SECTION 00 91 15

ADDENDUM NUMBER 6

- 1.01 DATE: JANUARY 22, 2021**
- 1.02 PROJECT: ELMORE SPORTS MEDICINE RENOVATIONS**
- 1.03 PROJECT NUMBER: DCM NO. 2020452; PSCA NO. 2018**
- 1.04 OWNER: ALABAMA A&M UNIVERSITY**
- 1.05 ARCHITECT: NOLA | VAN PEURSEM ARCHITECTS, PC**

JOB NUMBER
20132

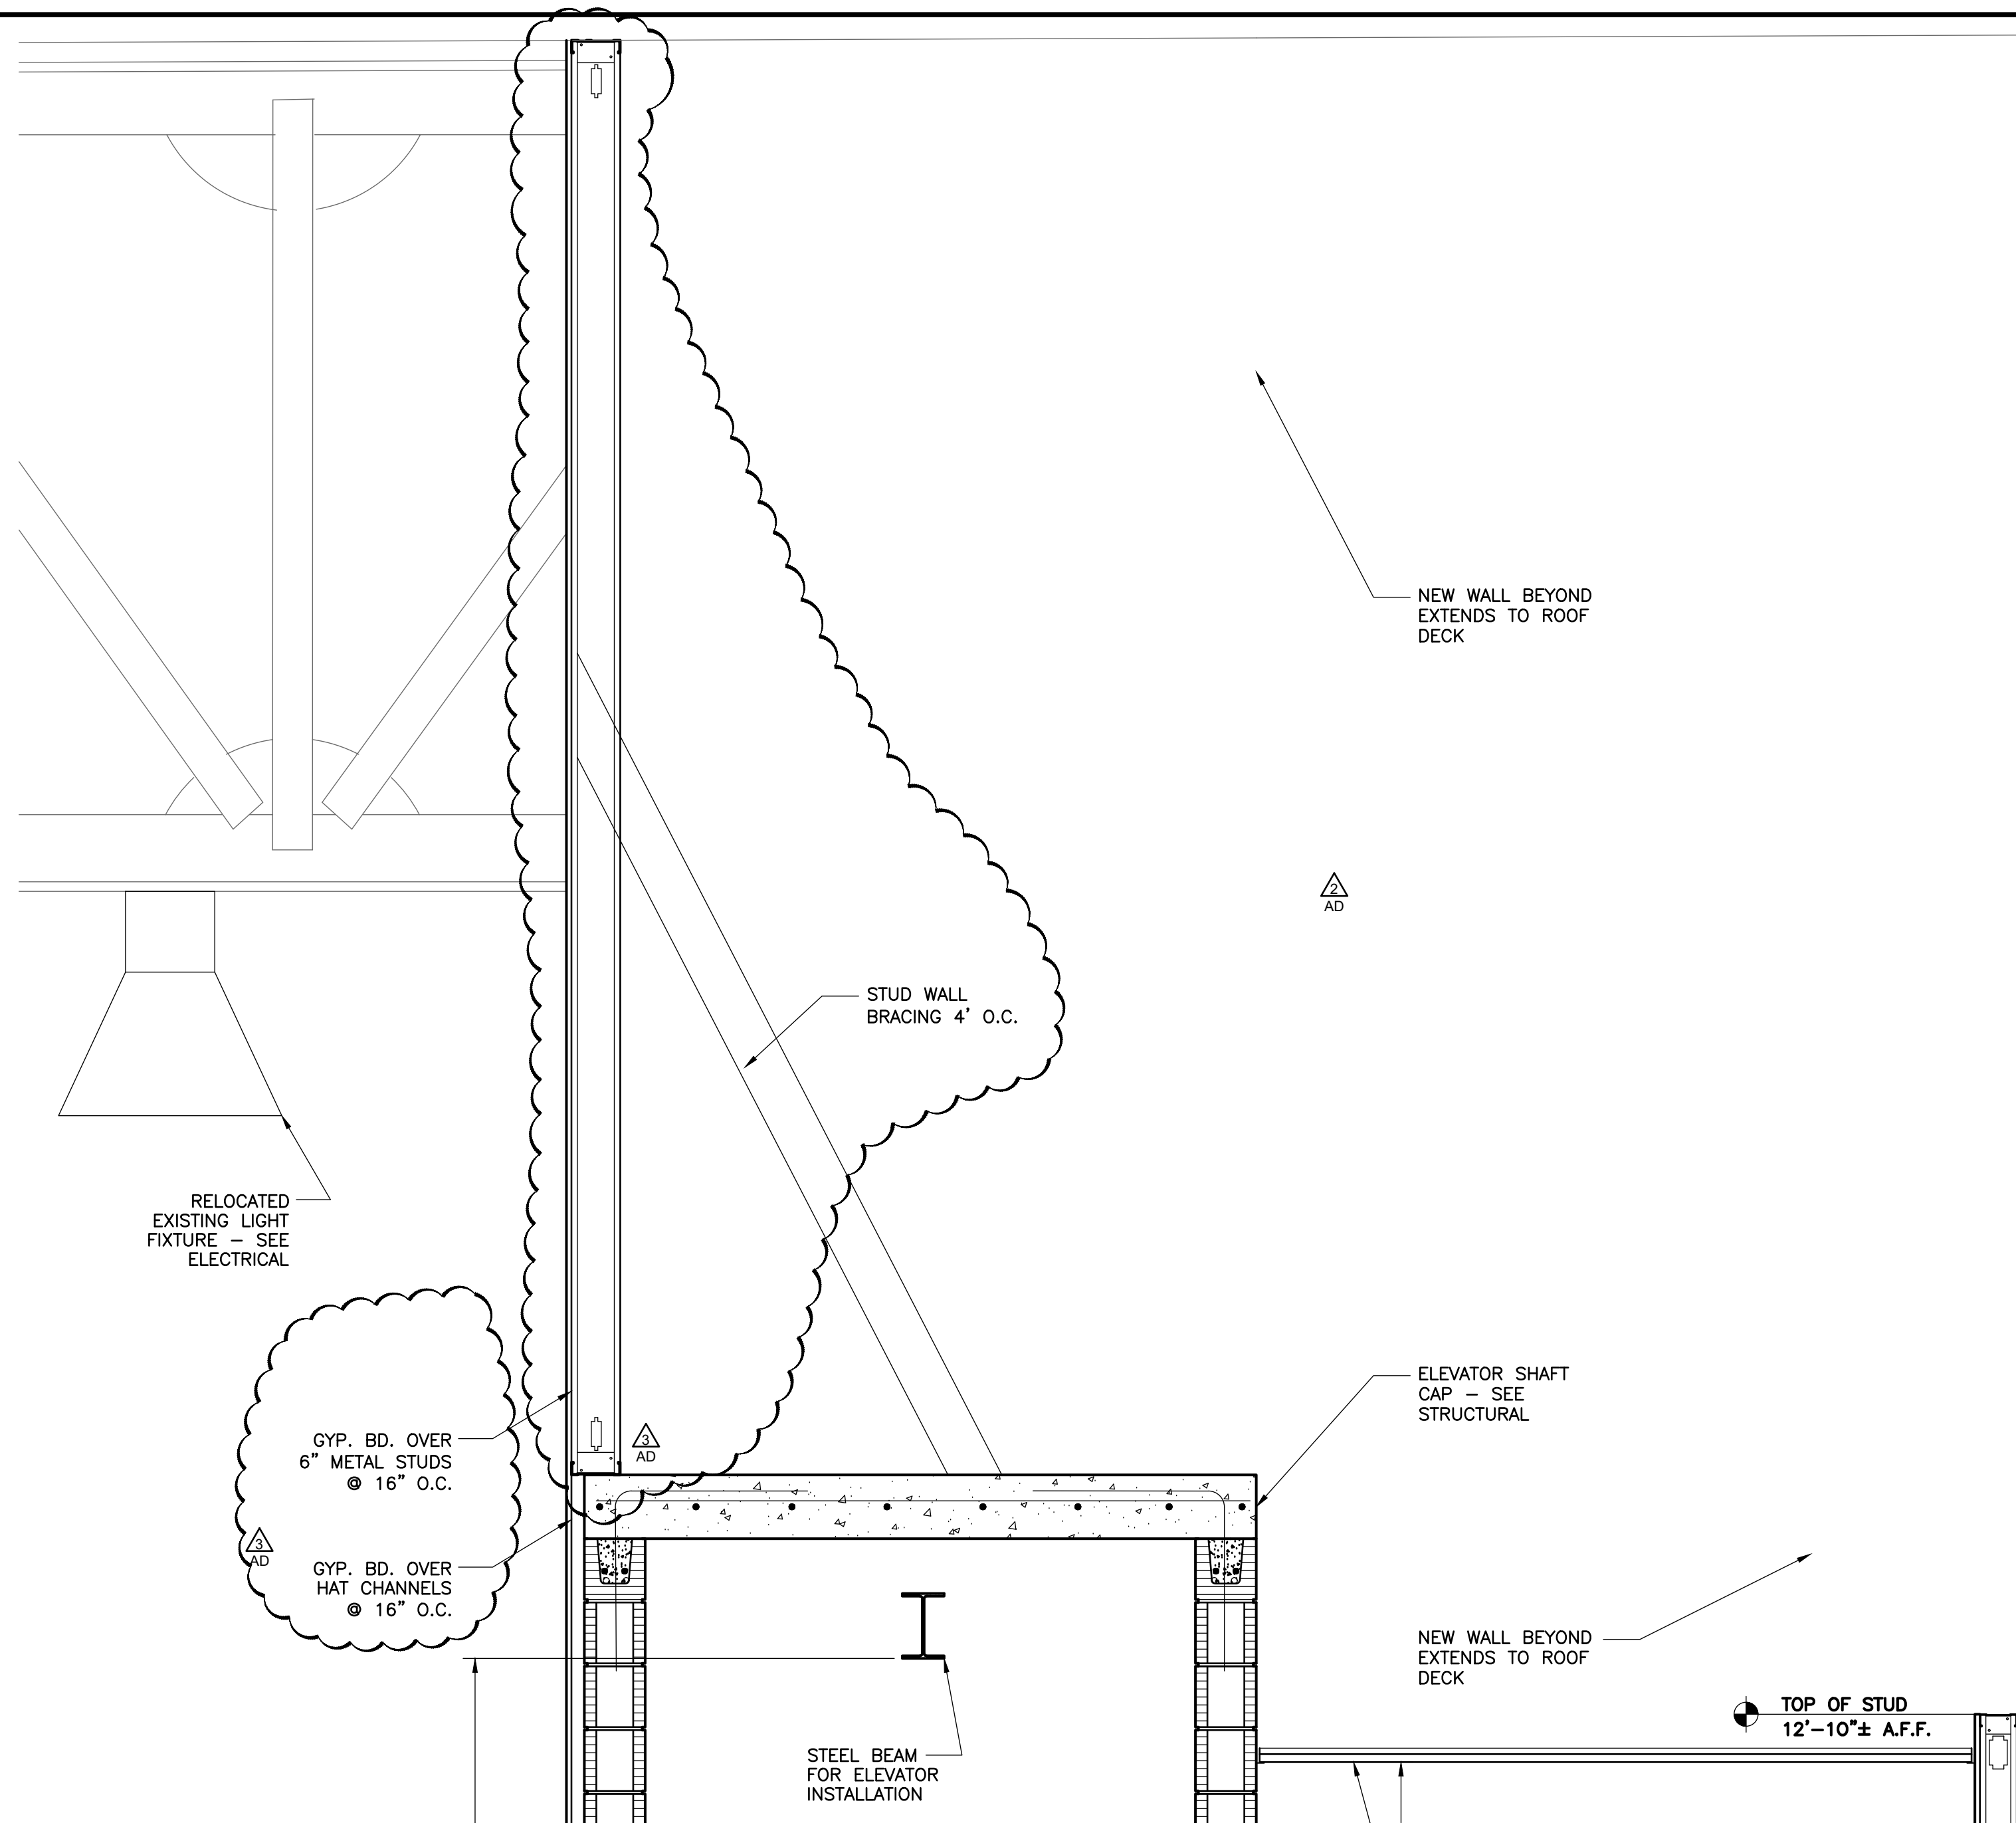
- A. Replace this sheet in its entirety. Revisions include the following:

1. Added painted accent stripe and large painted text.
2. Clarification of Mechanical grille location.
3. Revisions to elevator shaft wall finishes.
4. New soffit and lowered ceiling near elevator shaft.
5. Clarification of some corner guard locations.

A-3.3
OF

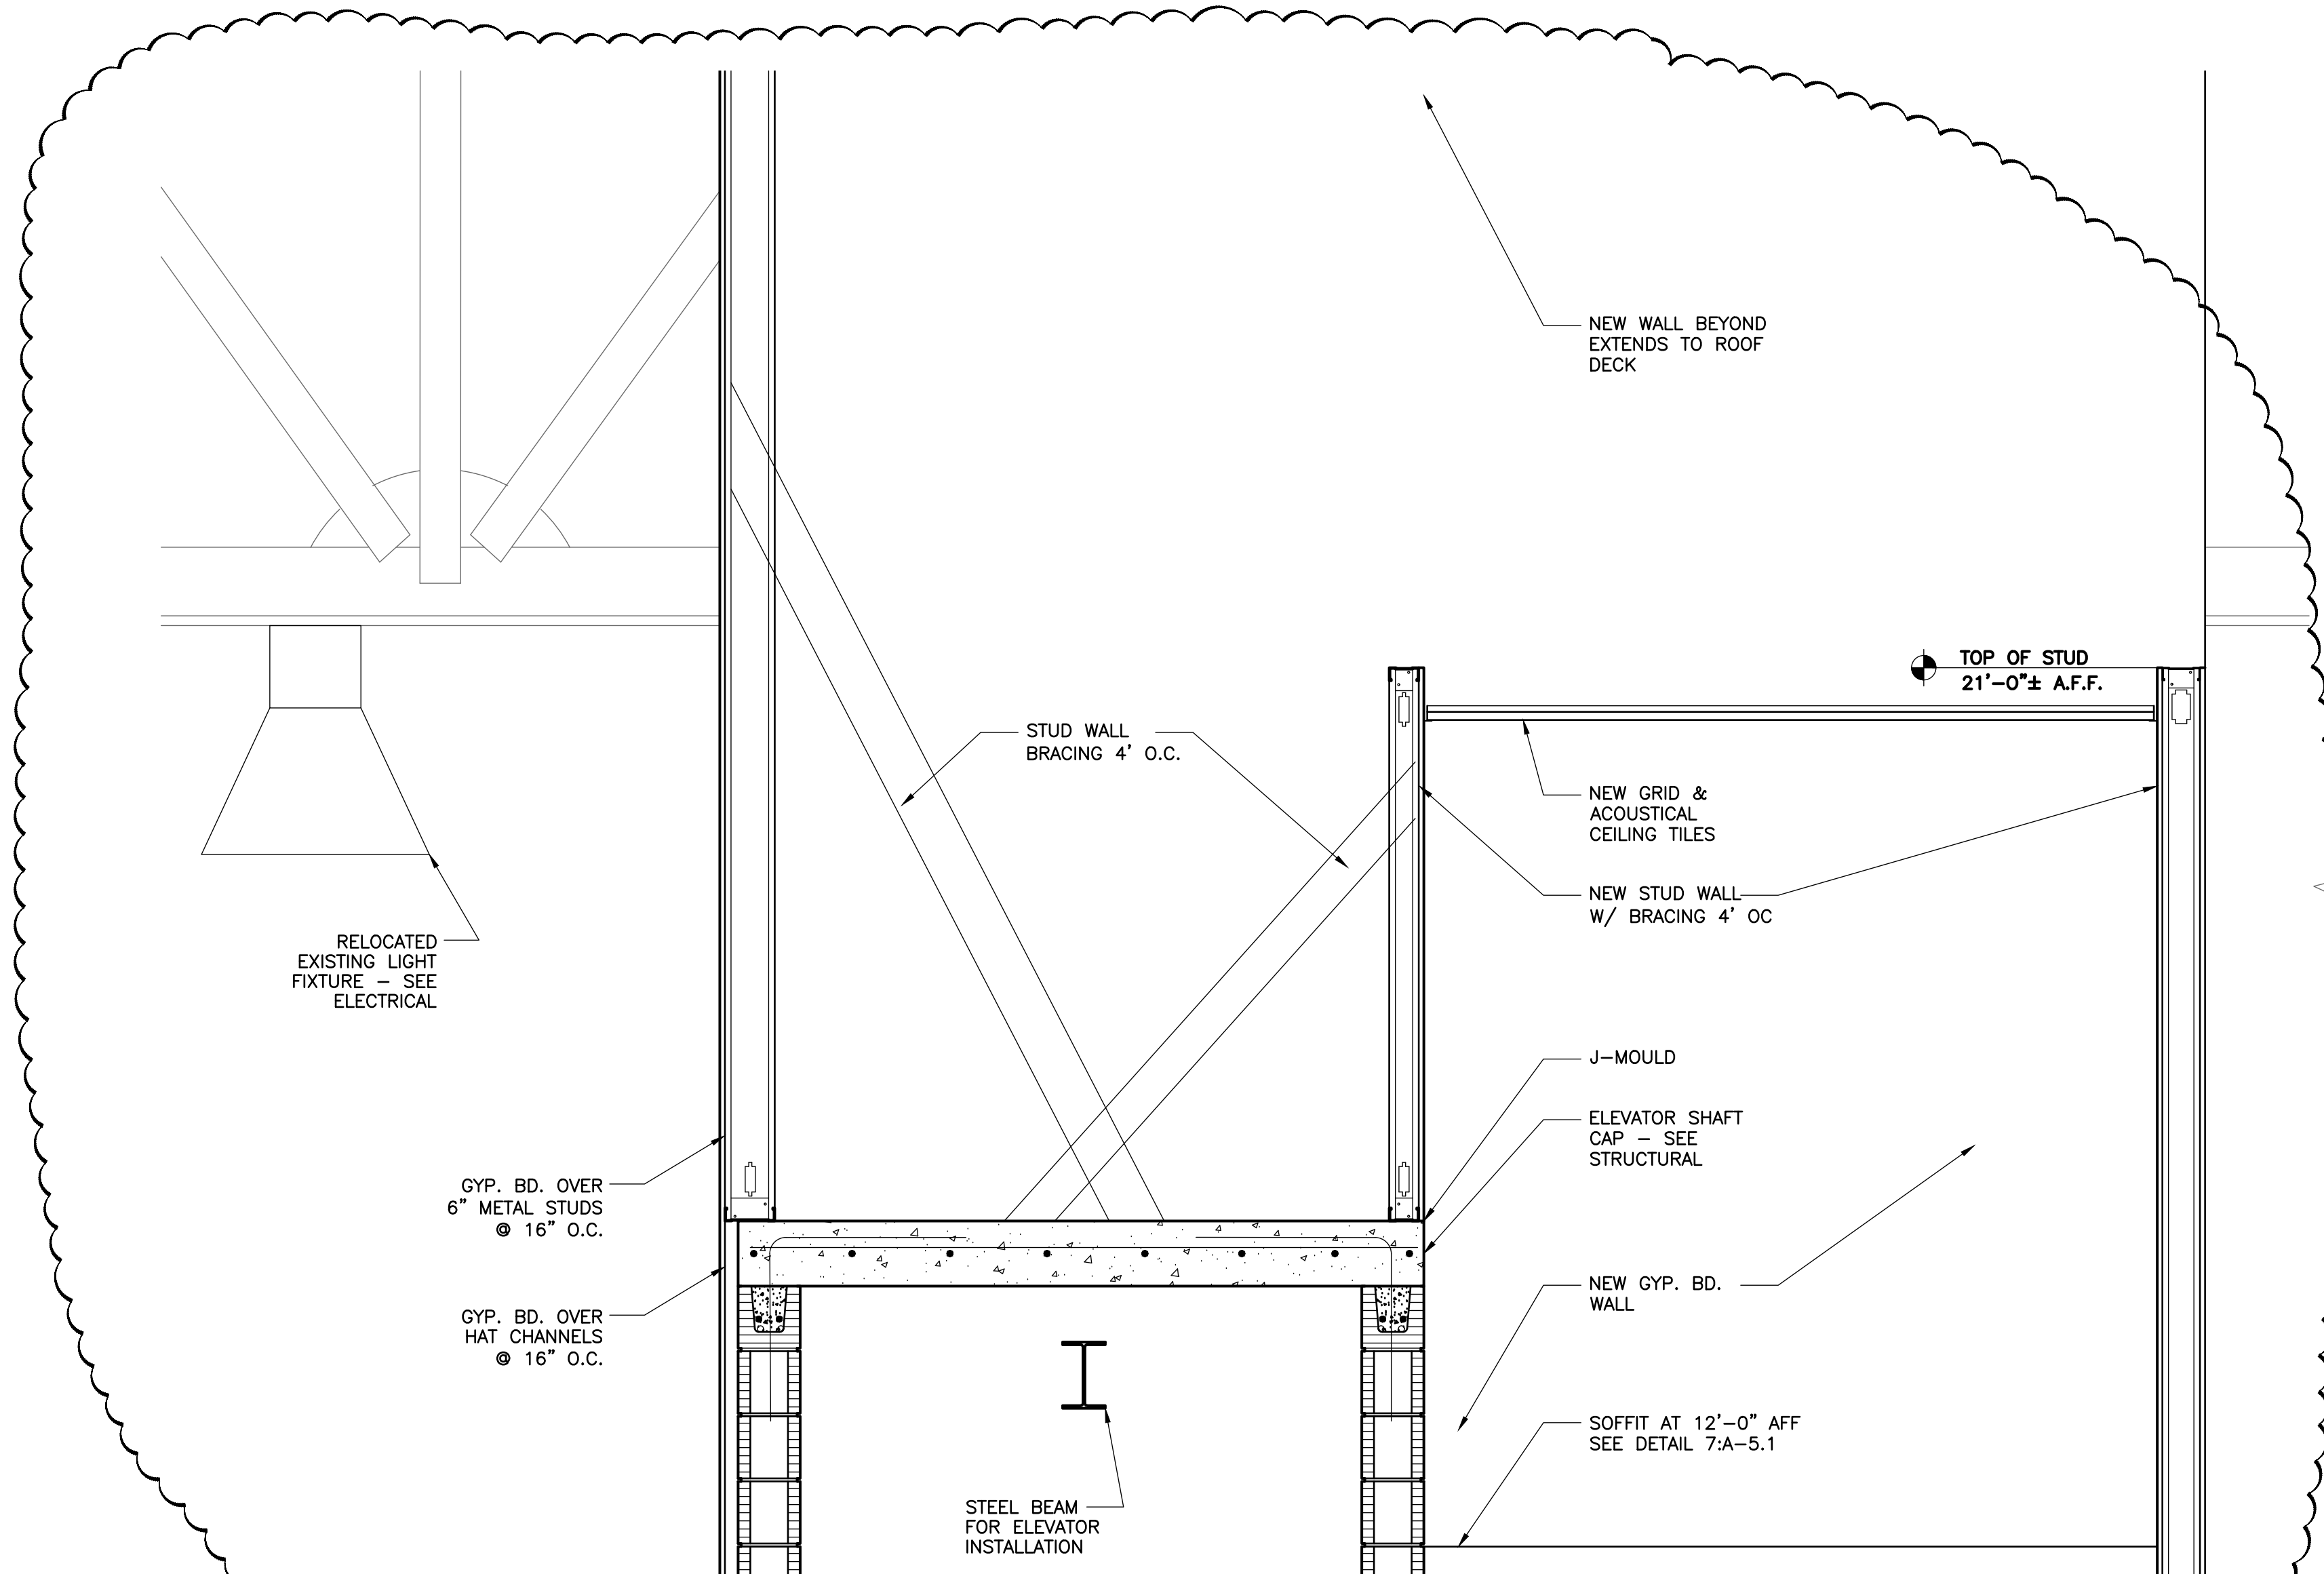
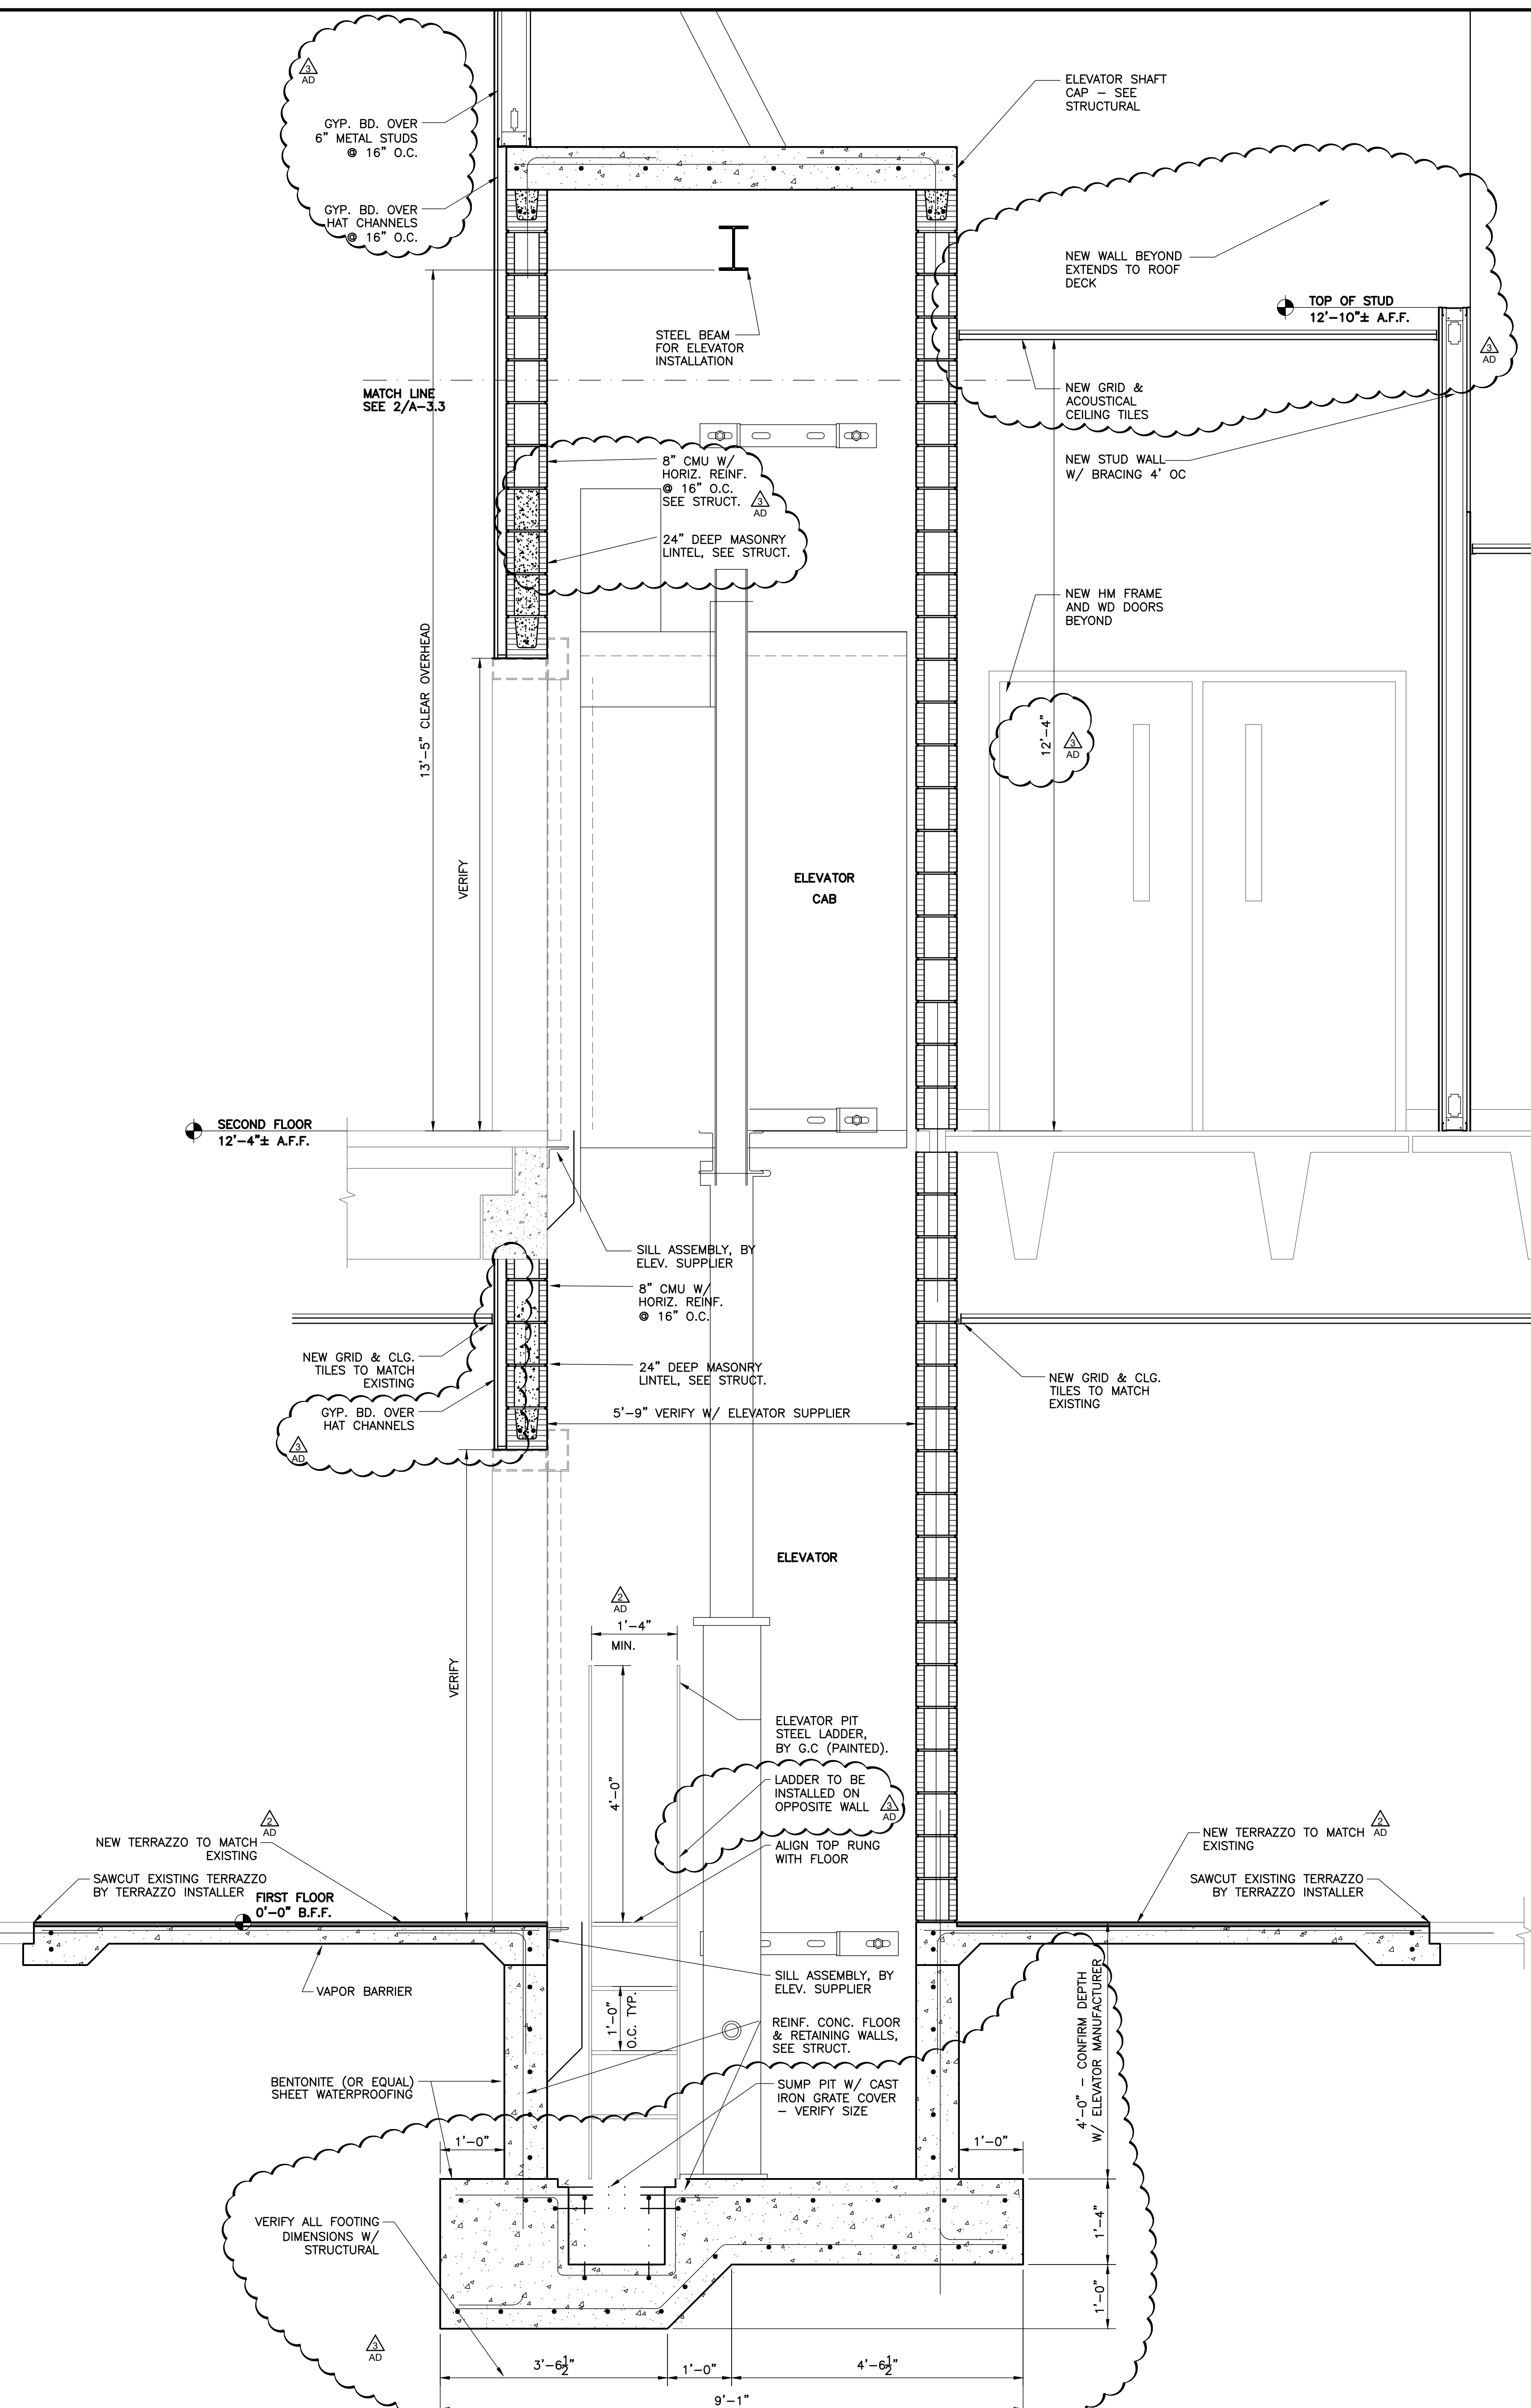
- A. Replace this sheet in its entirety. Revisions include the following:
1. Revisions to Sections 1/A-3.3 and 2/A-3.3.
 2. Revision to drawing scale of Sections 1/A-3.3 and 2/A-3.3.
 3. Added Section 3/A-3.3 Elevator Section.
